**Addendum No. 2**  
**July 29, 2024**

Project: Brandon Valley Elementary School  
Brandon, South Dakota  
Project #3023

Architect: Architecture Incorporated

**GYM SOUND REINFORCEMENT SYSTEM FUNCTIONAL BLOCK DIAGRAM**  
NO SCALE

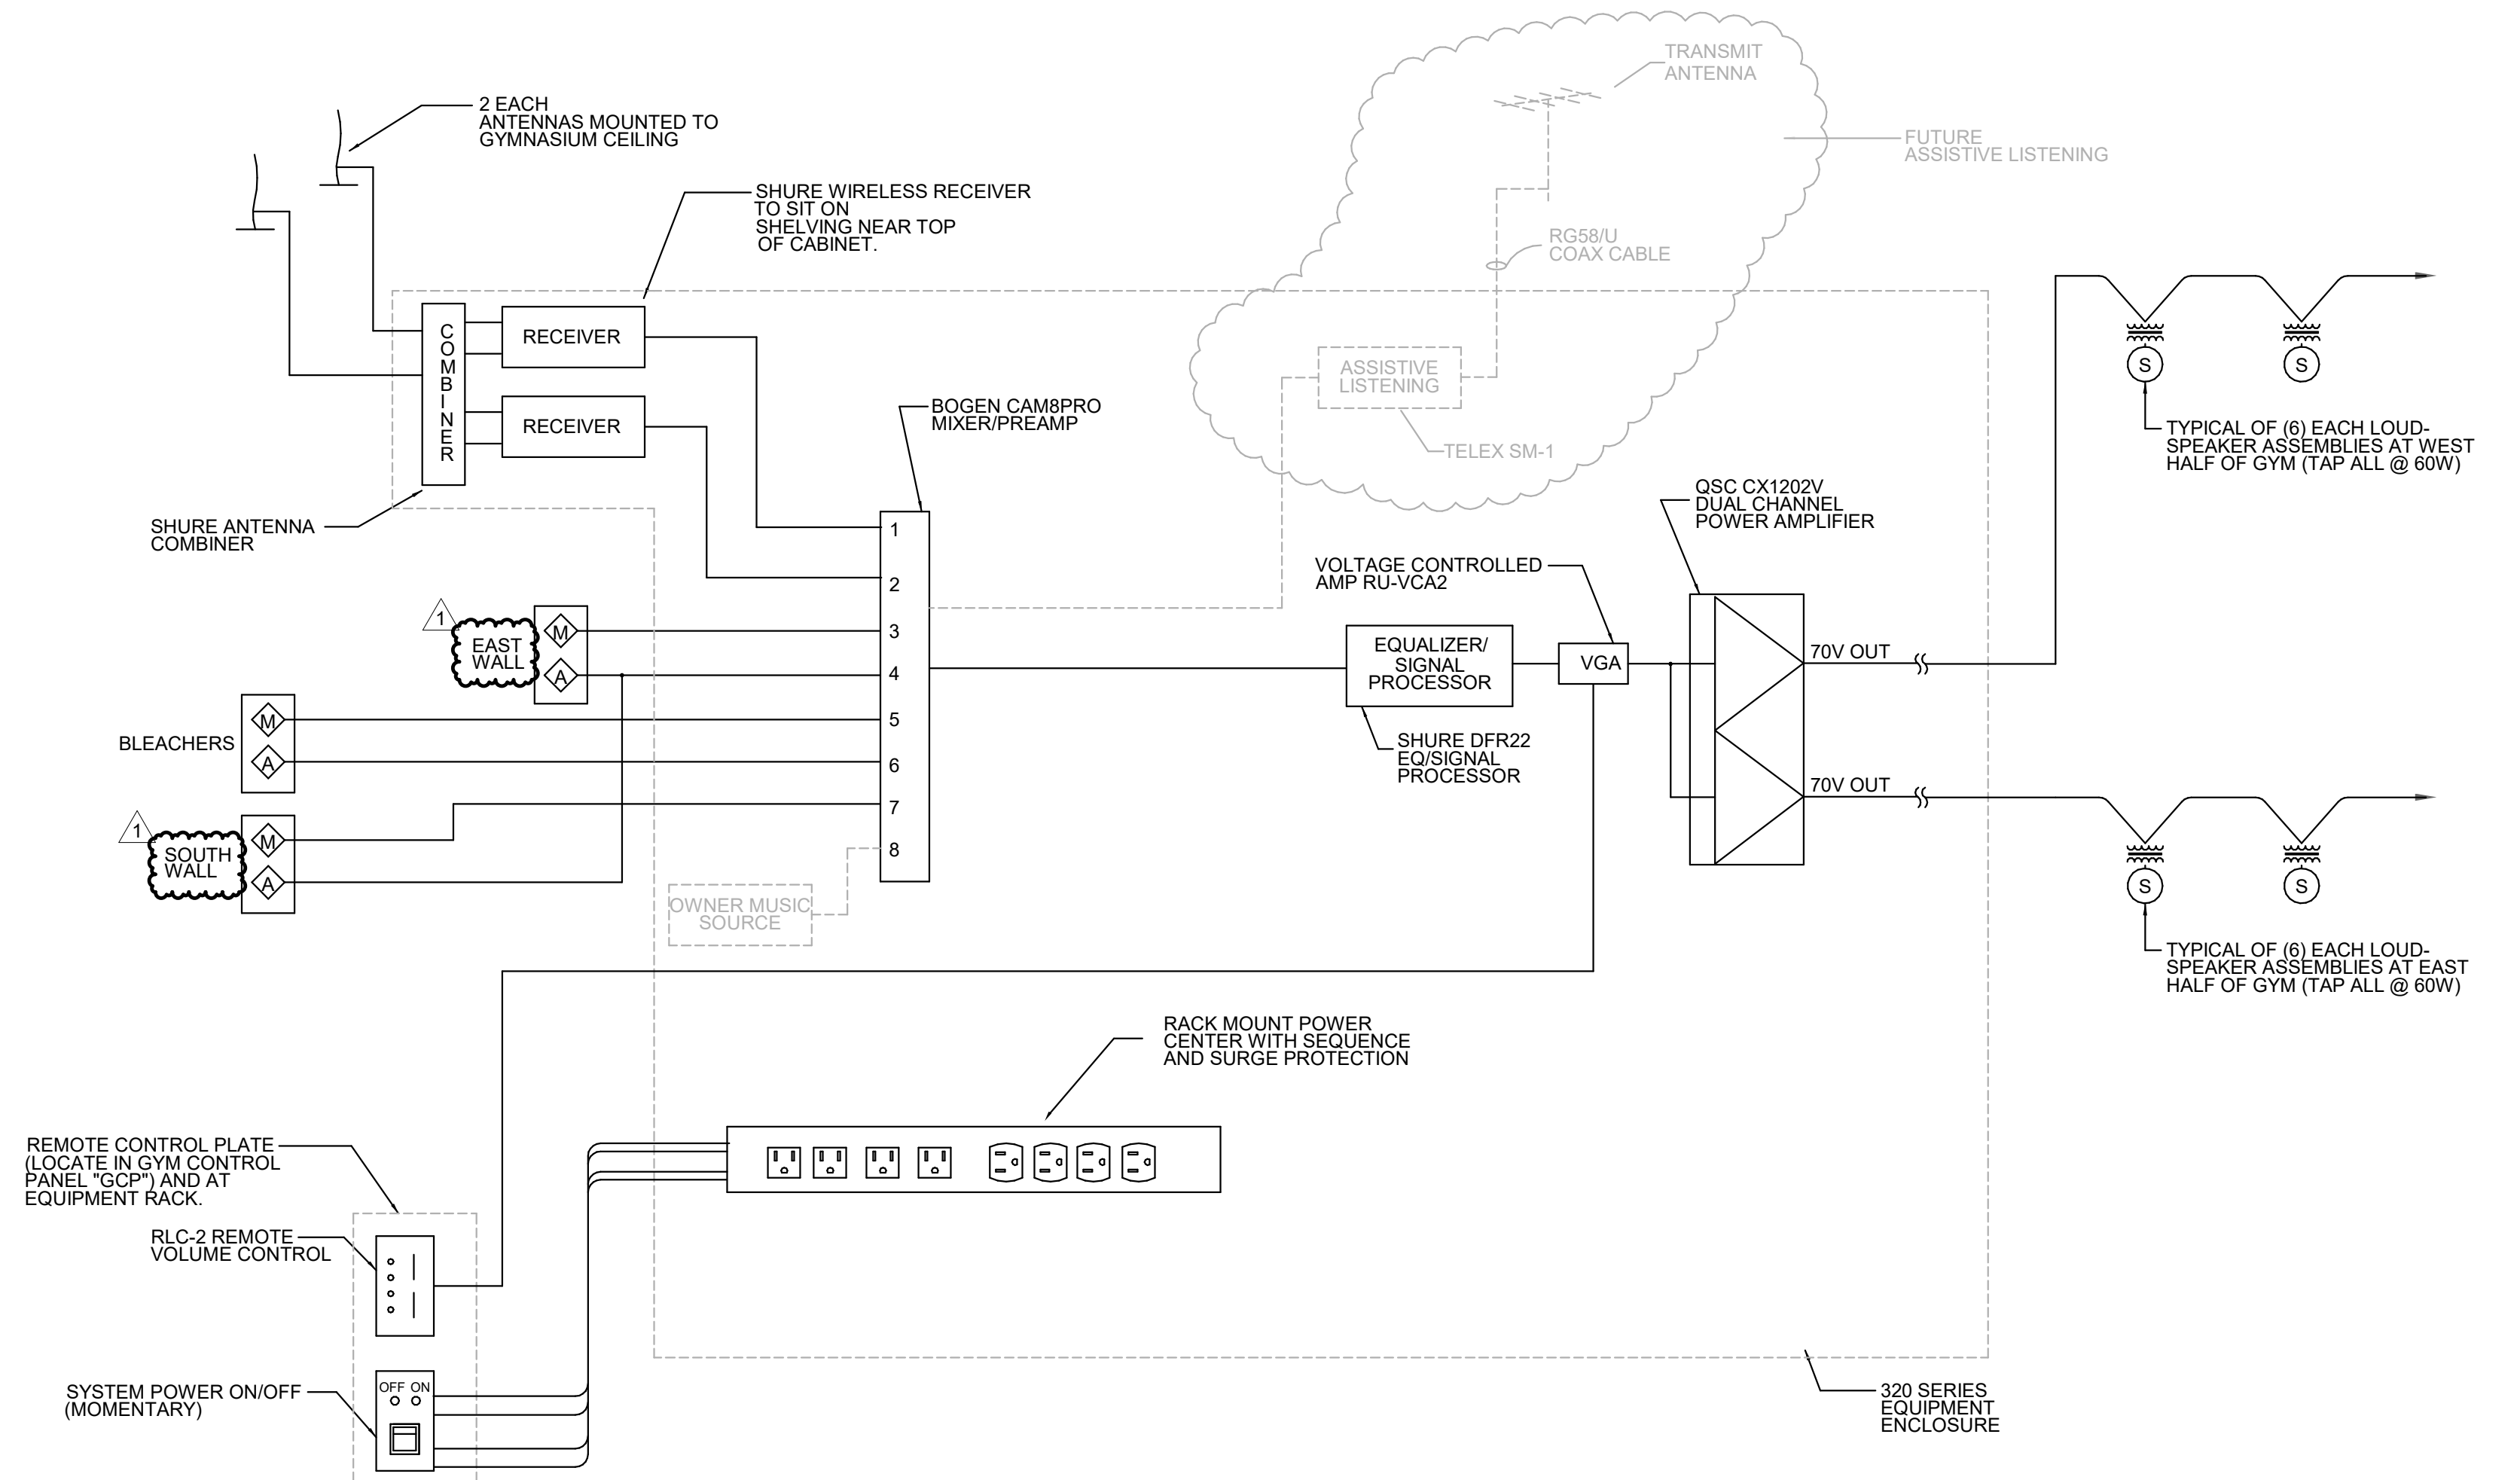
- a) Reference *revised* drawing Sheet 9.54 *revision* dated 7-26-2024, attached to the end of Addendum #2 for the following modifications:
  - i) Gym sound reinforcement system functional block diagram: Revised mic/aux input locations as indicated.
